Access Compliance Report

Public Rights-of-Way

(Curb Ramps)

Intersection ID: 10022357	Main Street: CAMERON_VALLEY_PY	Cross Street: N/A	Location: NE
ADA ID: 12A2BCED8DCE	Ramp Type: PerpDiag	Initial Pass/Fail: Fail	Overall Compliance: No
Severity Score: 33.75			
Codes/Mitigation Info/Possible Solution		Field Measurements/Component Compliance

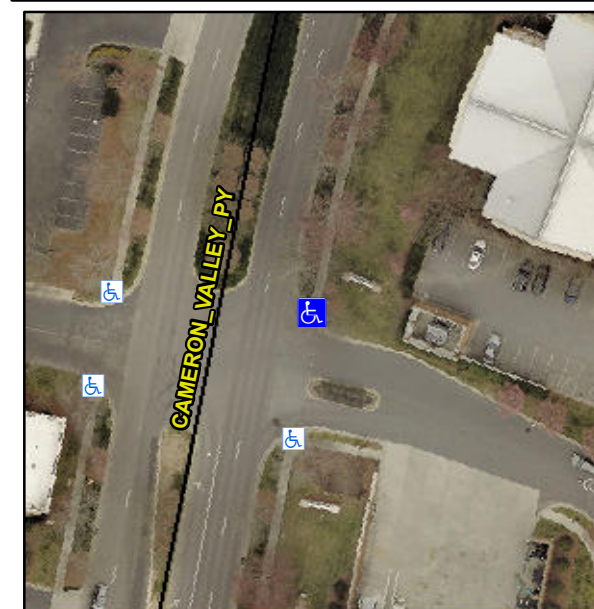
Not Found, R304.5.1, R304.2.2, R304.5.3

Compliance	Description	Data	Compliance	Description	Data
N/A	Ramp Length (in)	57.0	No	Ramp Slope (%)	10.2
No	Ramp Width (in)	37.5	No	Ramp XSlope (%)	6.8
N/A	Flare Type LT	N/A	N/A	Flare Type RT	N/A
N/A	Flare Slope LT (%)	N/A	N/A	Flare Slope RT (%)	N/A
N/A	Flare Traversable LT?	N/A	N/A	Flare Traversable RT?	N/A
N/A	Landing Length (in)	N/A	N/A	DWS Provided?	N/A
N/A	Landing Width (in)	N/A	N/A	DWS Contrast?	N/A
N/A	Landing Slope (%)	N/A	N/A	DWS Length (in)	N/A
N/A	Landing X Slope (%)	N/A	N/A	DWS Full Width?	N/A
N/A	Landing Curb? (Y/N)	N/A	N/A	DWS Offset (in)	N/A
N/A	Shared Landing?	N/A			
N/A	Gutter Ponding?	N/A	N/A	Gutter Slope (%)	N/A
N/A	Gutter Lip Ht (in)	N/A	N/A	Gutter X Slope (%)	N/A
N/A	Painted X Walk1?	No	N/A	Painted X Walk2?	No
	X Walk 1 Direction	To NW		X Walk 2 Direction	To SW
N/A	X Walk 1 Width (in)	N/A	N/A	X Walk 2 Width (in)	N/A
	X Walk 1 Slope (%)	2.7		X Walk 2 Slope (%)	2.6
	X Walk 1 X Slope (%)	5.3		X Walk 2 X Slope (%)	4.5

Remove & Replace Curb Ramp With Two New Directional Ramps or Equivalent.
